Subject: Proposed Revisions to Spruce Terraces Subdivision, Lots 1-27 MOA Case S-12420

**S12420 Spruce Terraces Subdivision, Lot 1-27**

Preliminary Plat of:

SPRUCE TERRACES SUBDIVISION

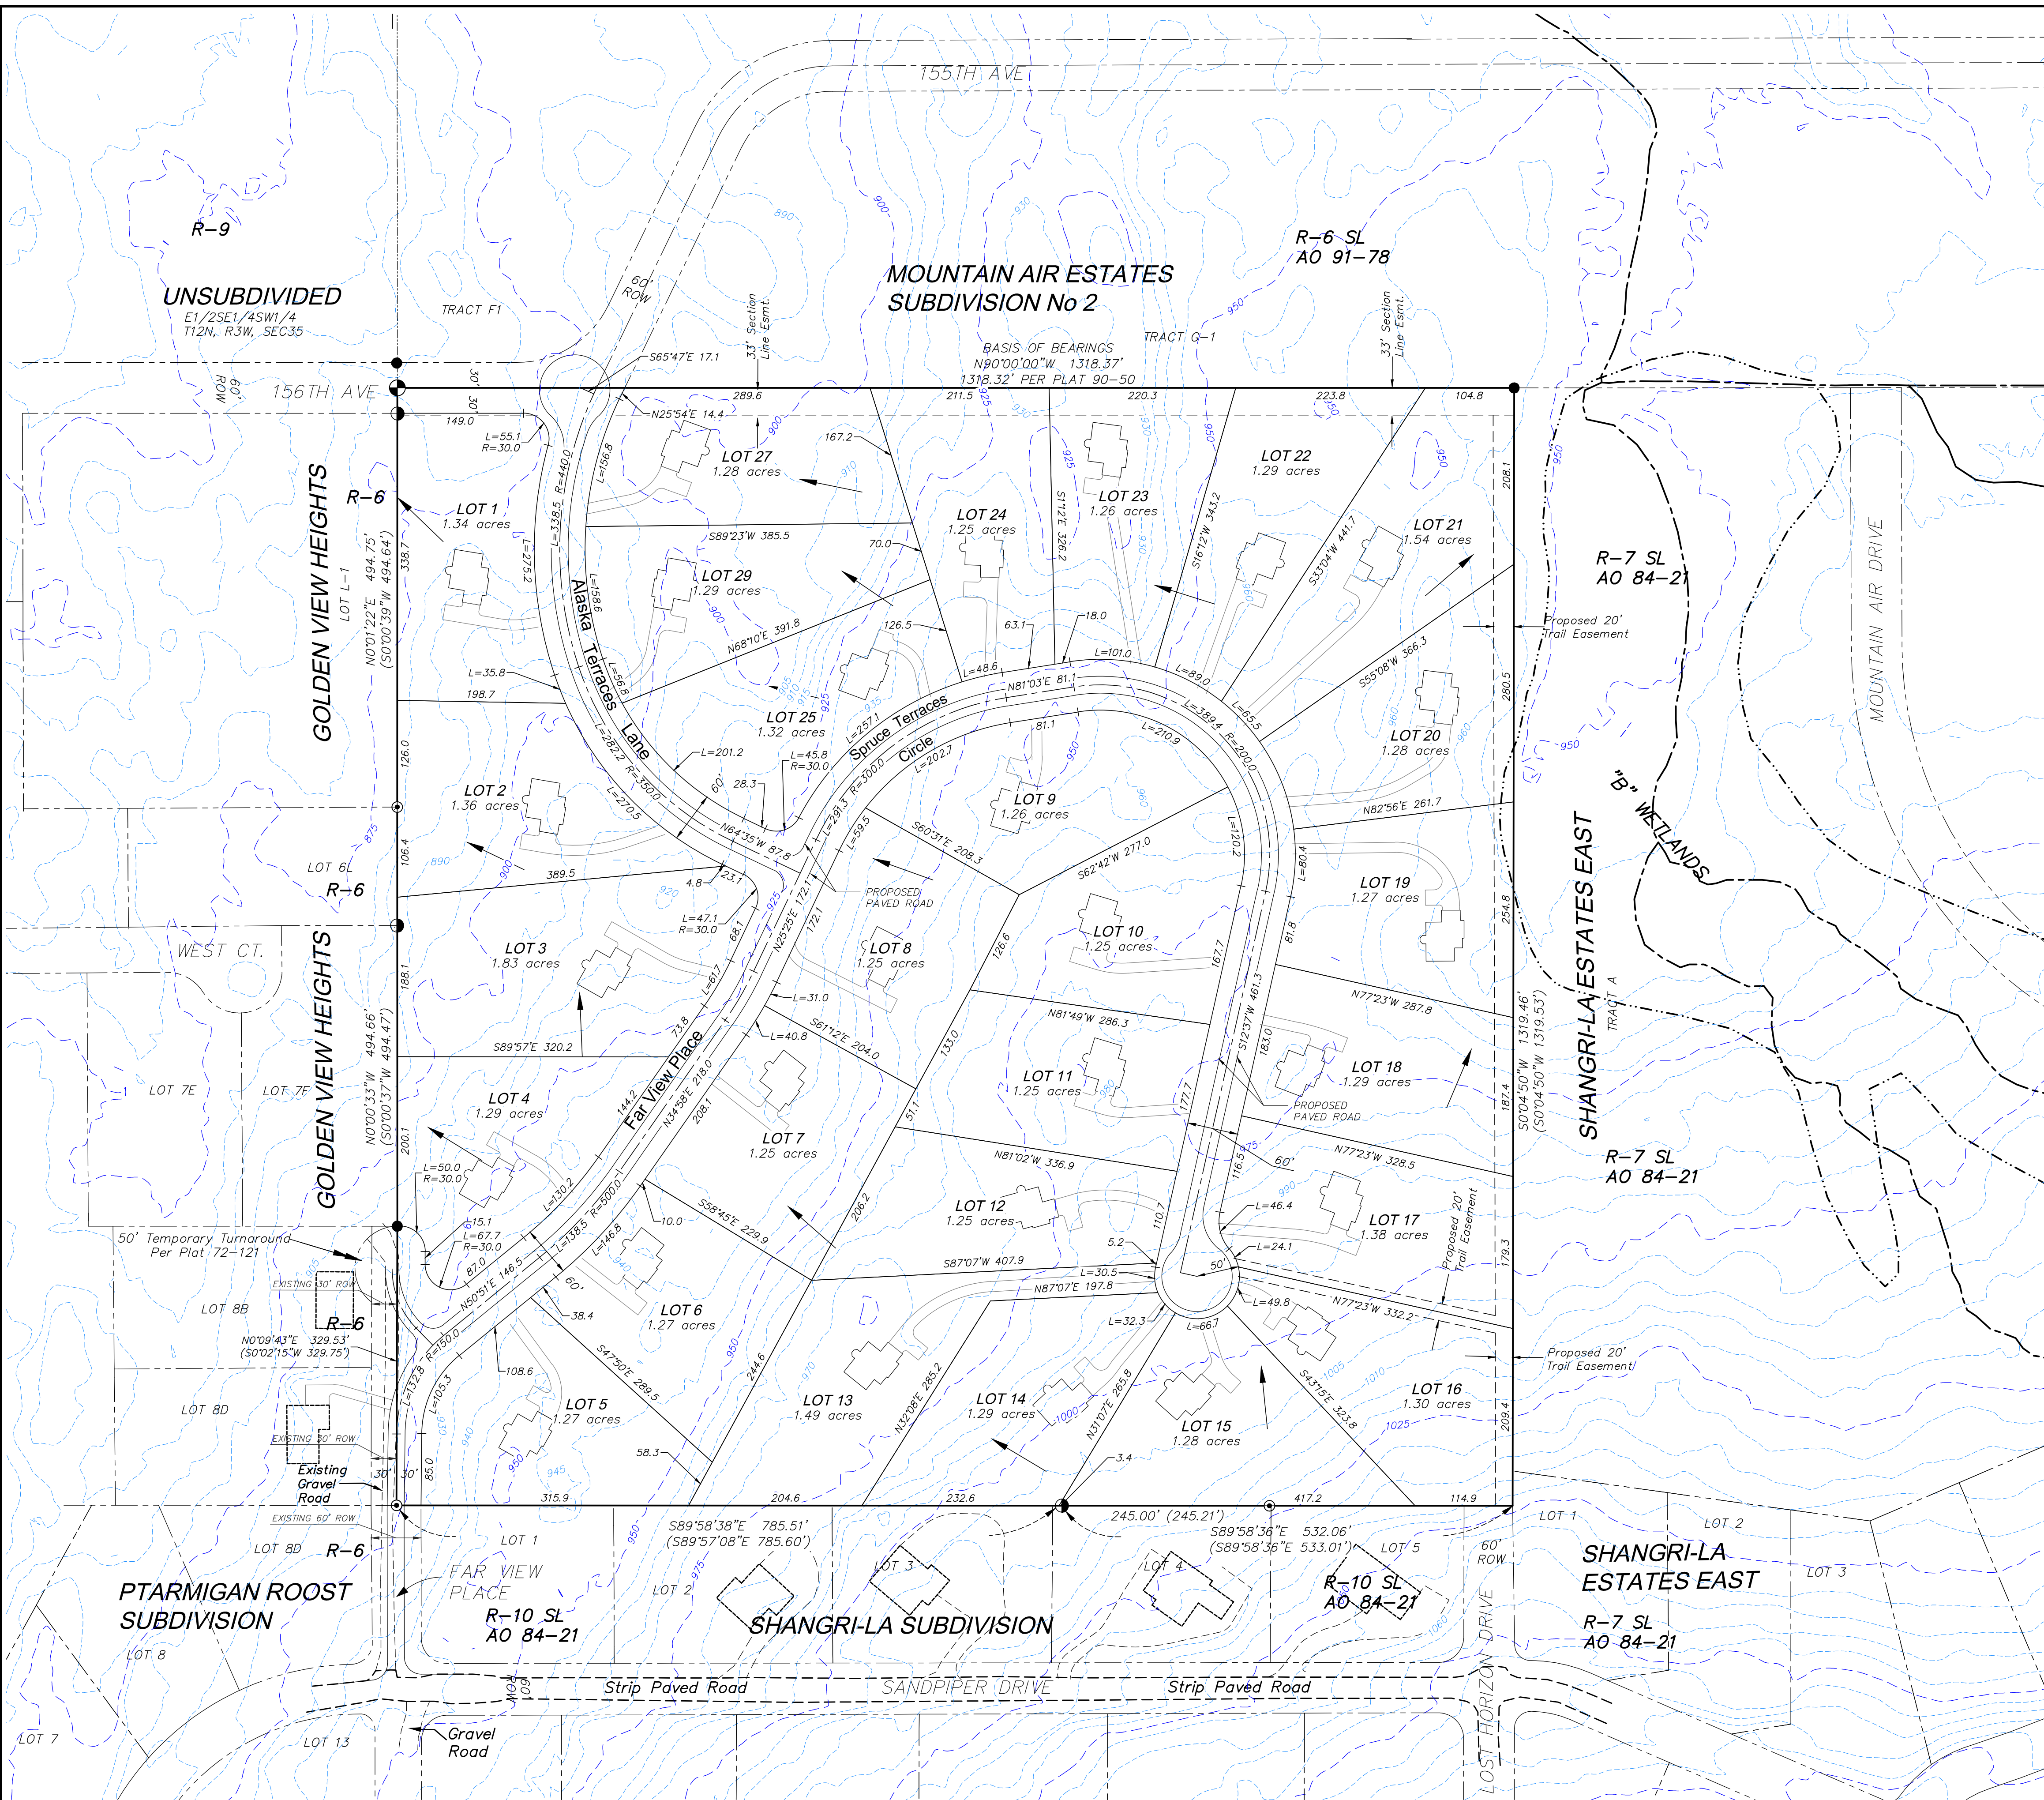
REVISIONS 12-20-2020:

1. Revise outer boundary to reflect surveyed location of property corners
2. Added plat notes (as revised in application).
3. Made some revisions per Summary of Action S12420 dated 12/4/2019.
